Model: PC8000 Serial #: N/A	Jul. 29, 2020
Product Bulletin # PC-049 v 1.0

PC8000 Ramp Channel Repair Work

Figure 1: Rework Side Support Detail View

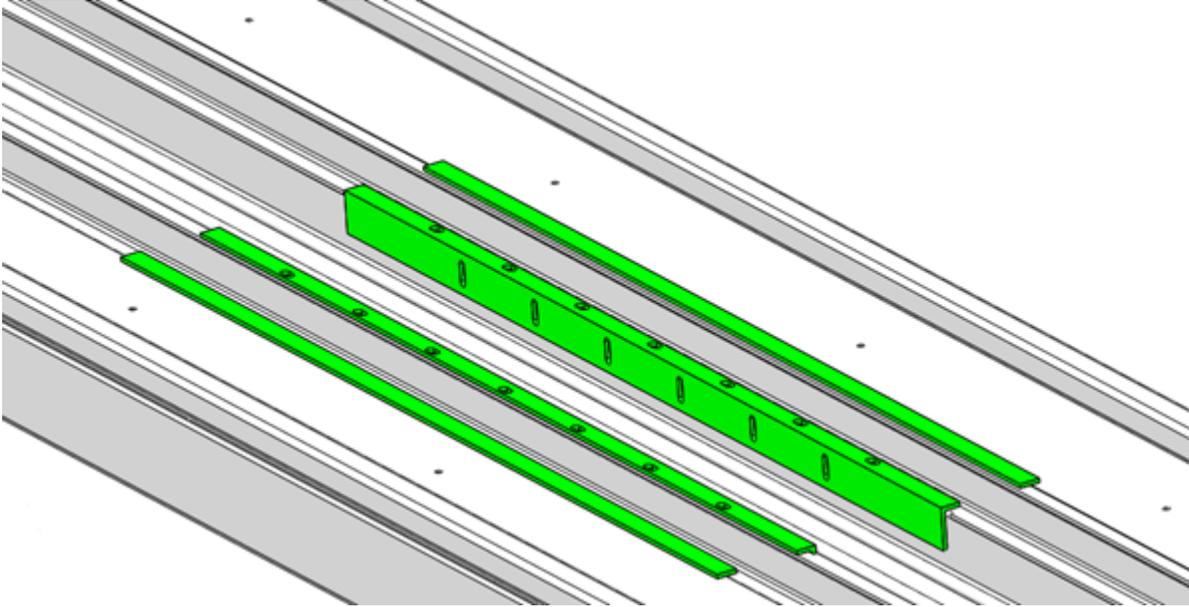
As shown in Figure 1 and Figure 2 on page 2, the L-angle and flat bar reinforce the area where the carrier rollers may cause damage to the ramp C-channels.

Figure 3: 42' Ramp supports location

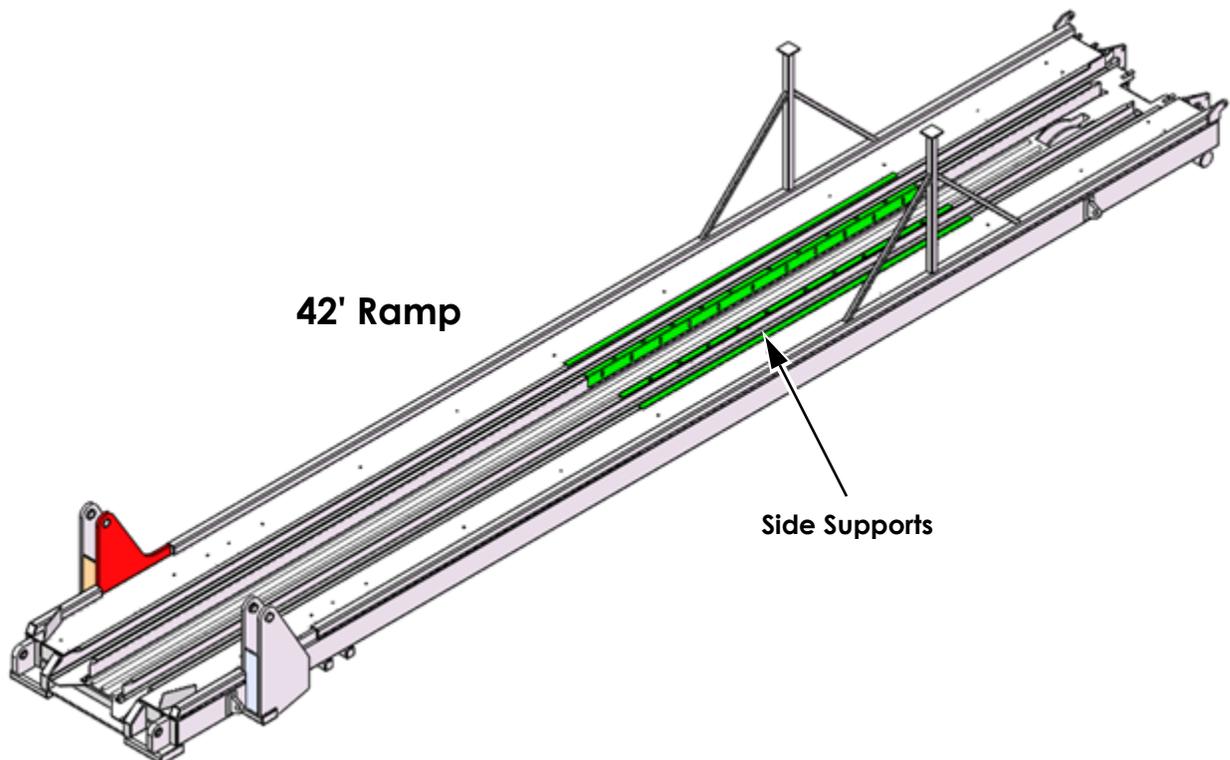
Support bars 170" long, located towards top of ramp.

Figure 4: 46' Ramp supports location

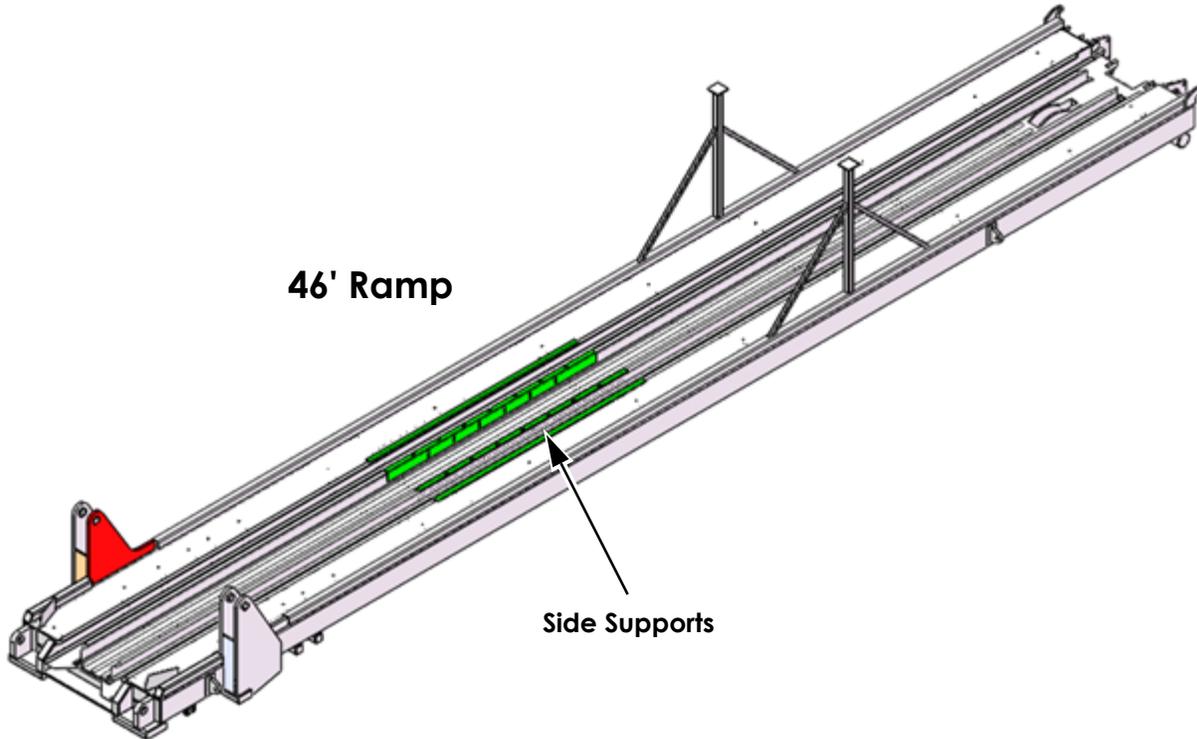
Support bars 118" long, located towards bottom of ramp.

Figure 5: 48' Ramp supports location

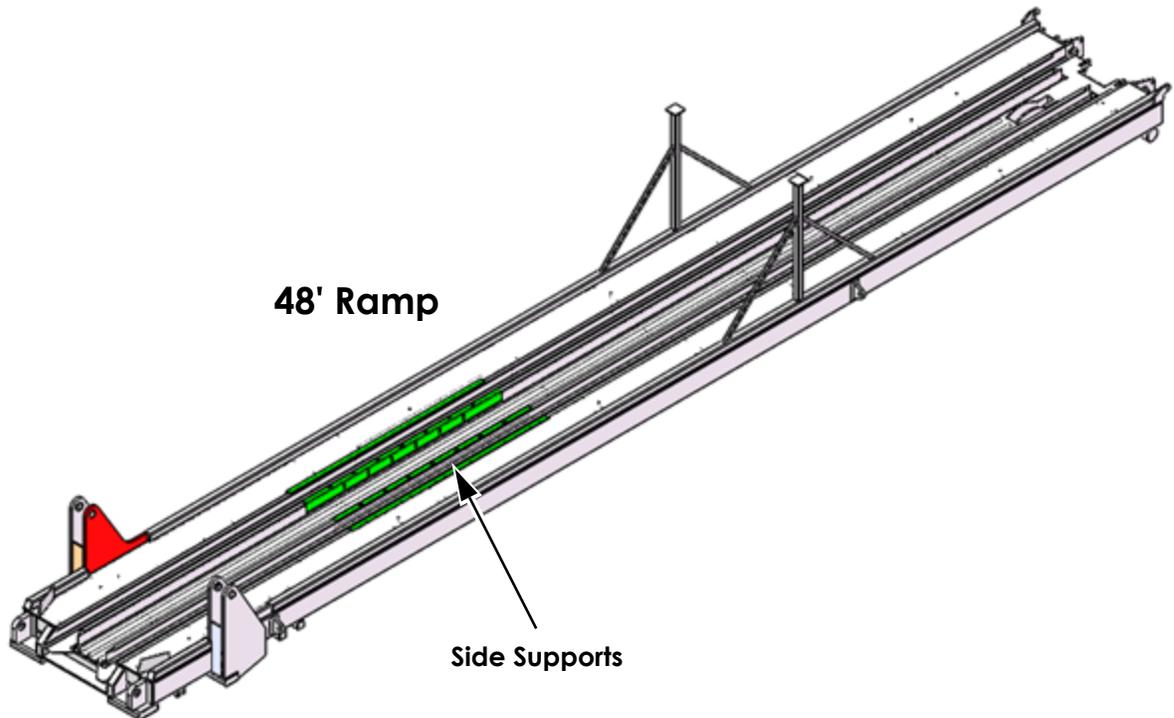
Support Bars 118" long, located towards bottom of ramp.
